### ADDENDUM NO. 2

ALBANY ELEMENTARY BUILDING ADDITION & RENOVATION PROJECT 700 W. STATE ST. ALBANY, IN 47320

OMS PROJECT NO. 22063

MARCH 25, 2023

- 1. Drawing A107 CLERESTORY PLAN & ELEVATIONS
  - A. Revise Details 2, 3, 4, 5, 6, 7, 8 and 9 as follows:

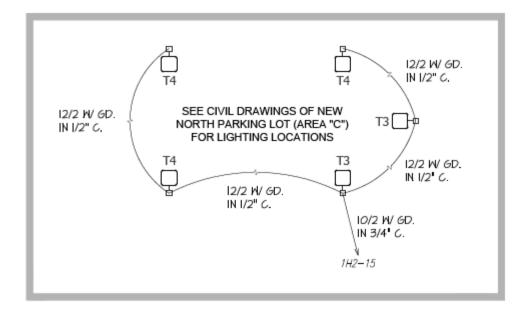
a. Delete all references to 074213.A1 Aluminum Composite Panels. The basis of design is to Provide 072423.C3 2" Exterior Insulation and Finish System at the Clerestory exterior walls. The ACM Panels are only provided at the Administration and Main Entry elevations due to cost limitations.

b. NOTE: Provide the roof membrane and coverboard below the Clerestory windows at areas receiving new roof. Also, it can be a Contactor's Option or a Voluntary Alternate to install EIFS below the storefront windows in lieu of turning up the roof membrane since either option will be watertight and will be visually acceptable.

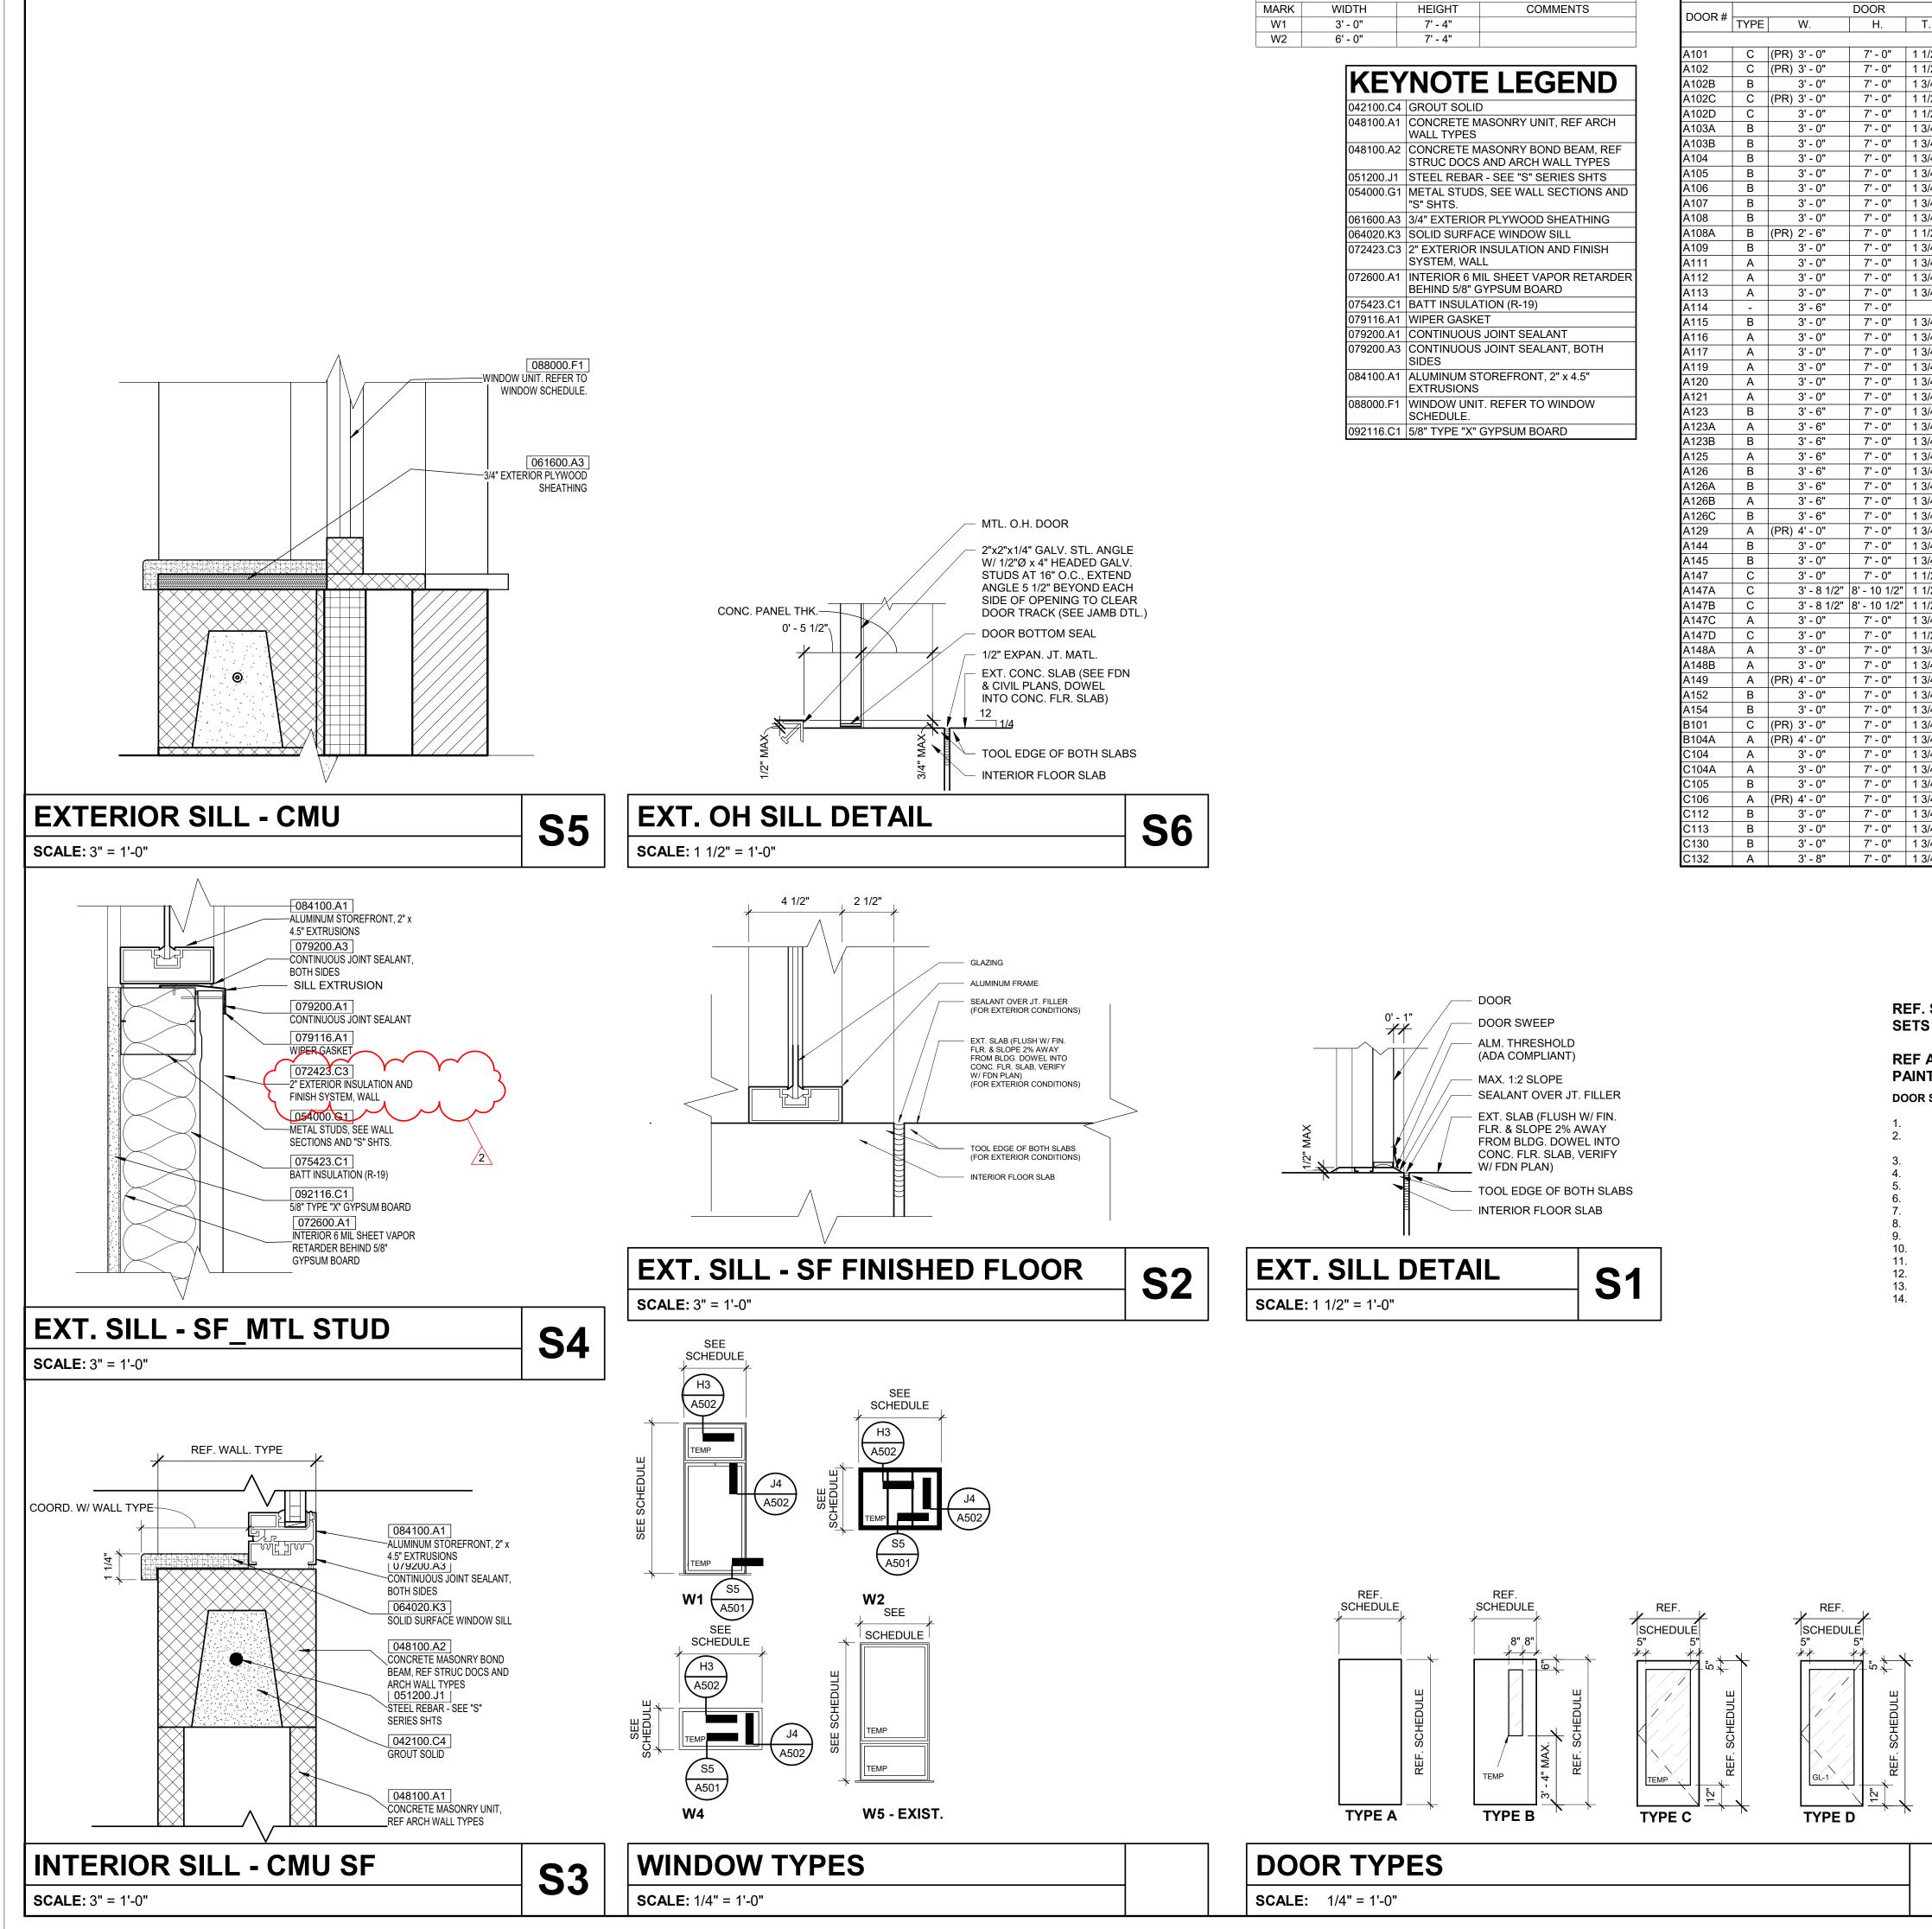
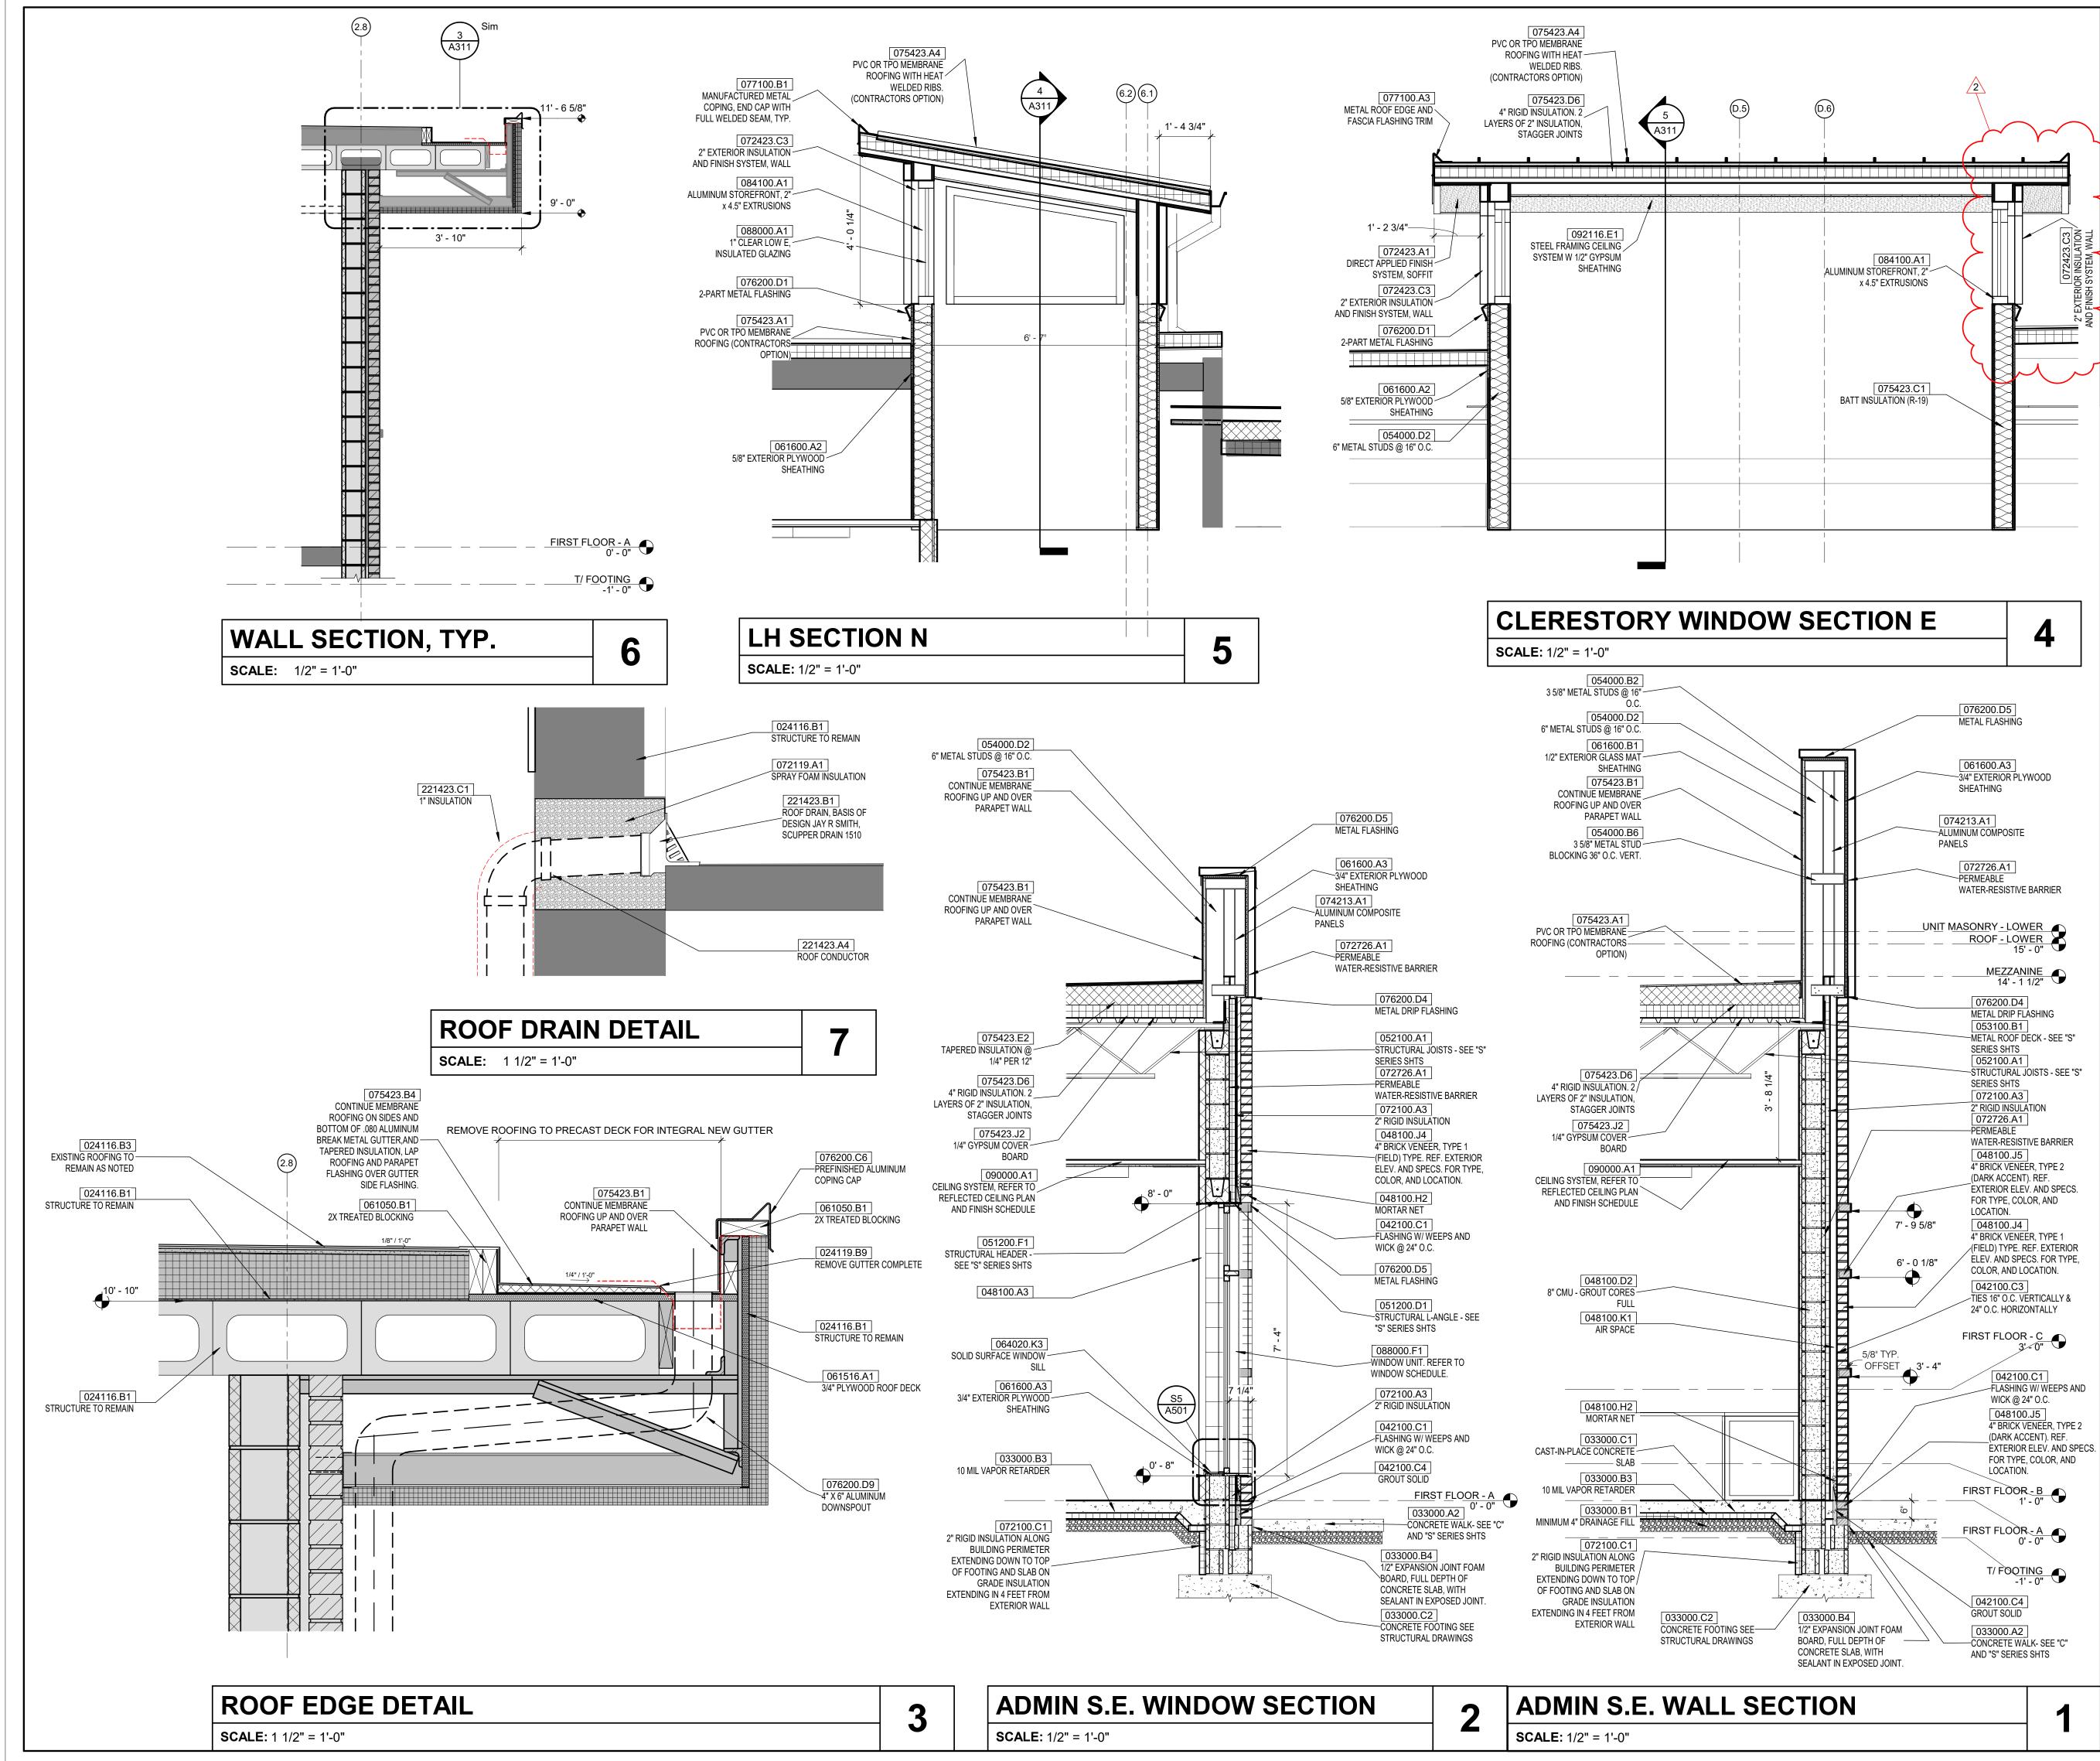
- 2. Drawing A311 WALL SECTIONS
  - A. Detail 4 revise Keynote to 072423.C3 2" Exterior Insulation and Finish System in lieu of 074213.A1 Aluminum Composite Panel.
- 3. Drawing A501 OPENING SCHEDULES & DETAILS
  - B. Detail S4 Revise Keynote to 072423.C3 2" Exterior Insulation and Finish System in lieu of 074120.A1 2" Insulated Metal Wall Panel.
- 4. Drawing A502 OPENING DETAILS & ELEVATIONS
  - C. Details H5 & J6 revise Keynote in to 072423.C3 2" Exterior Insulation and Finish System in lieu of 074120.A1 2" Insulated Metal Wall Panel.
